**RE: Twentymile Coal, LLC - Foidel Creek Mine (Permit No. C-82-056), Minor Revision (MR24-325)
Adequacy Response #1**

Twentymile Coal, LLC (TC) Has reviewed your adequacy review dated April 12th, 2024. TC is providing the following responses to the comments or concerns noted in the review:

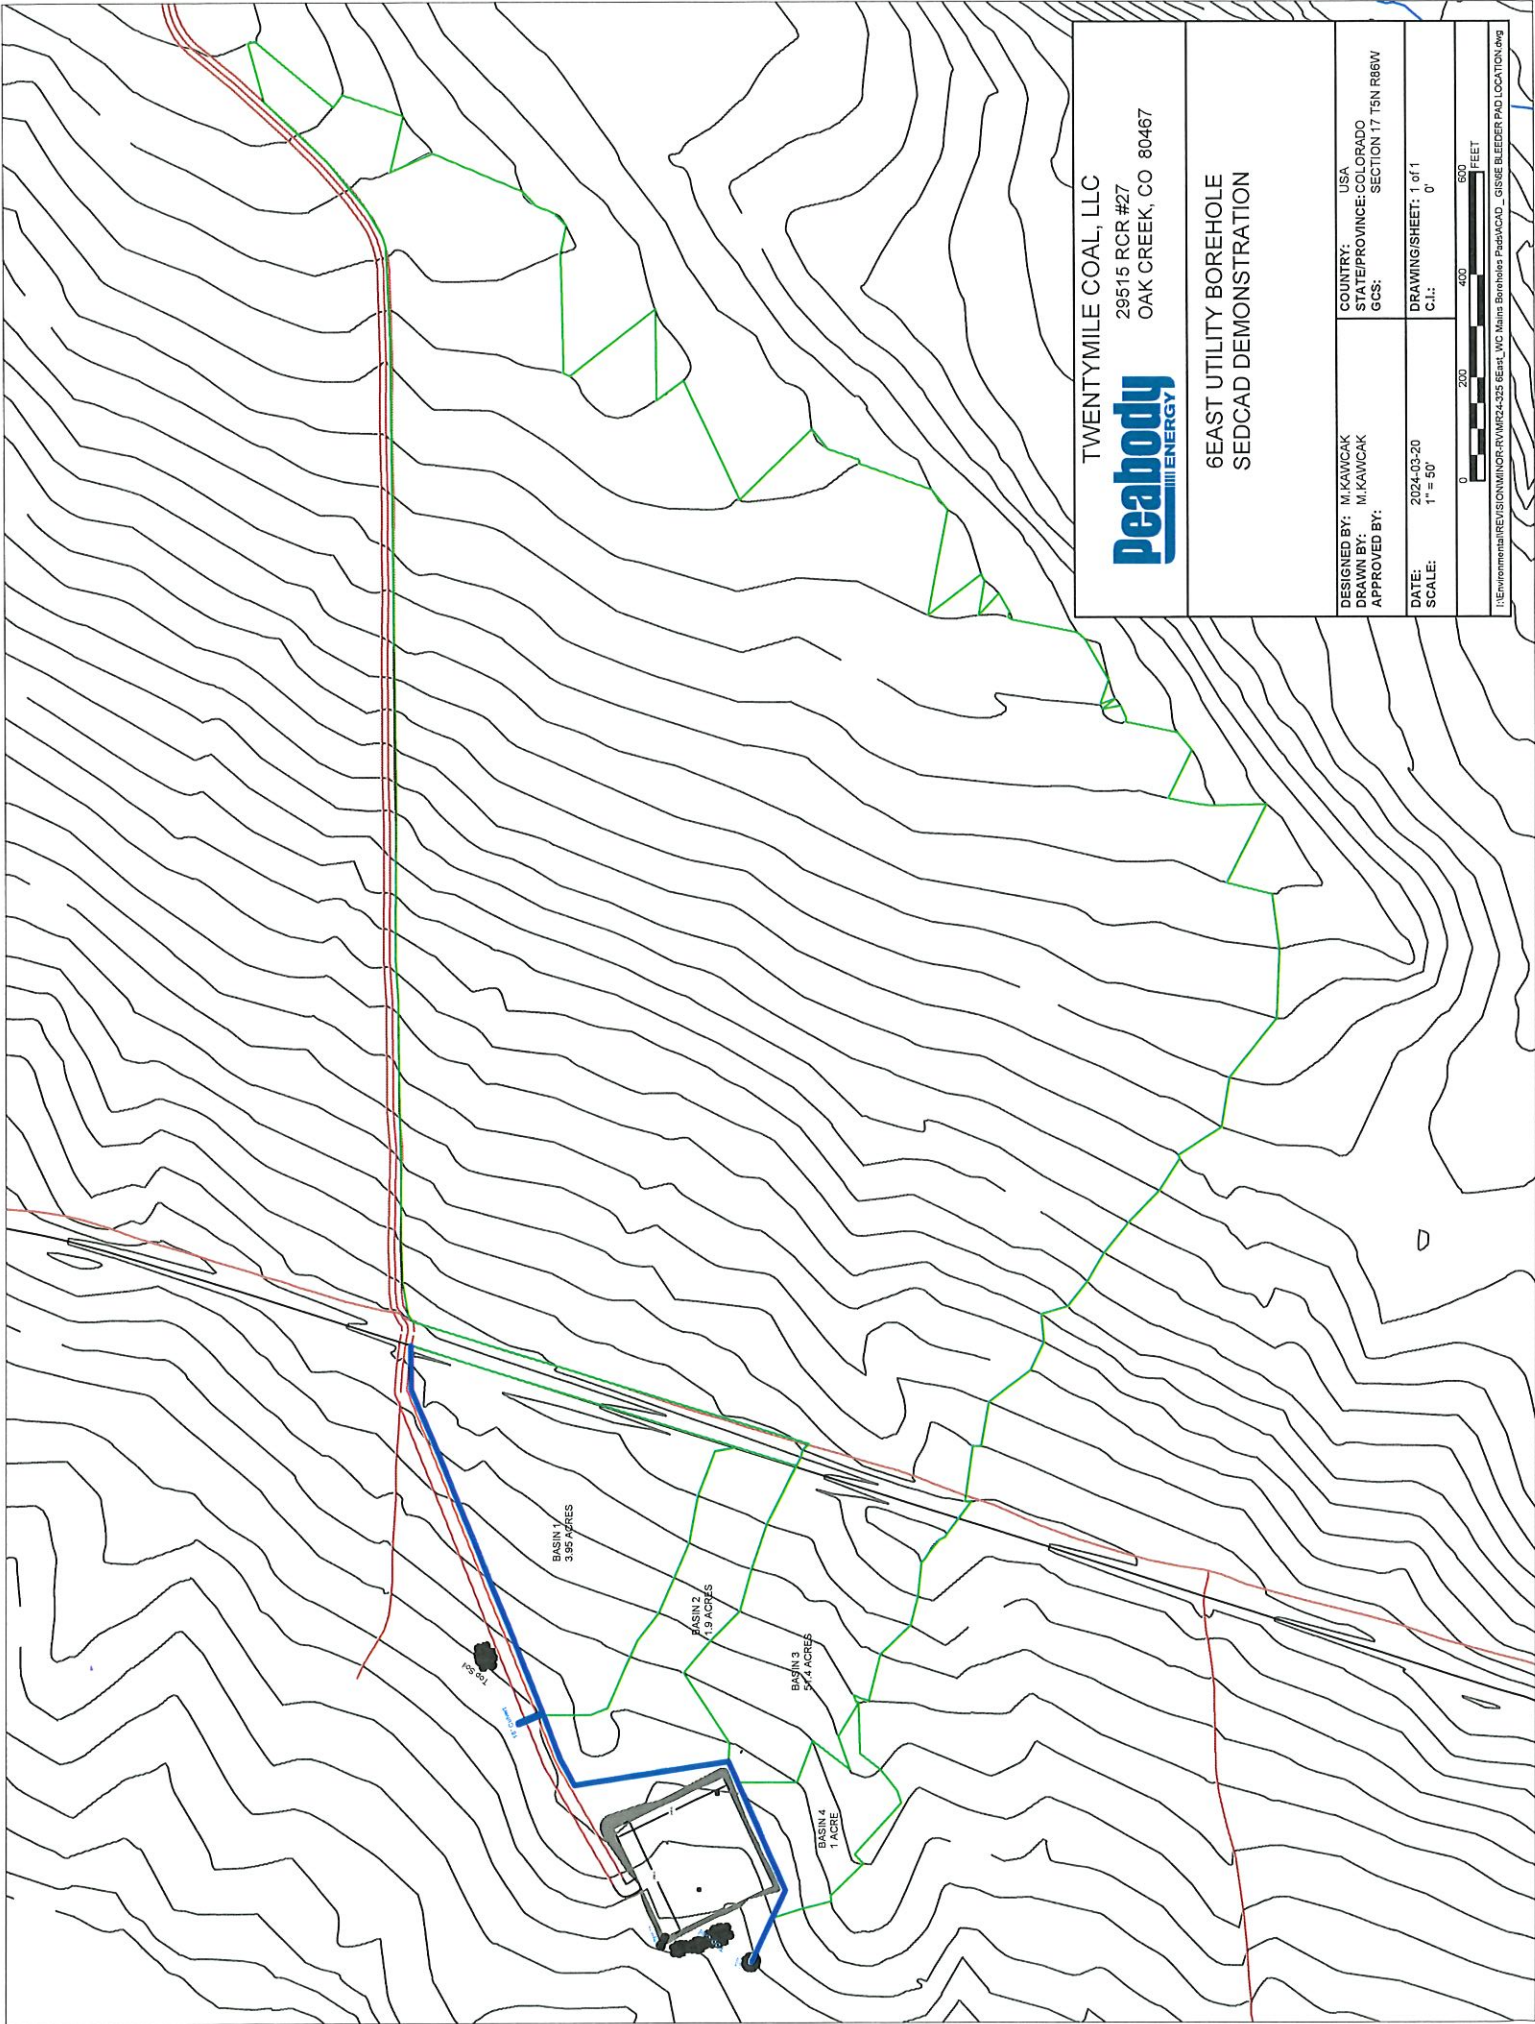
- 3) The MR325 cover letter requests that both new borehole sites be certified as small area exemptions (SAE). While the borehole pads meet the size and drainage type requirements for SAE pursuant to Rule 4.05.2(3)(b)(i), the Division requires a technical demonstration that runoff from these areas will not breach effluent standards. A SEDCAD demonstration is the Division's preferred method, as similar demonstrations have been completed previously for other boreholes onsite. However, a RUSLE equation may also be used.

- a) A SedCAD demonstration has been completed for each site and is submitted with this response. The 6E site has a large watershed that will require diversion ditches to divert the water around the site and not contribute to the stormwater flows of the disturbed area. The WC Mains Site is at the top of a watershed
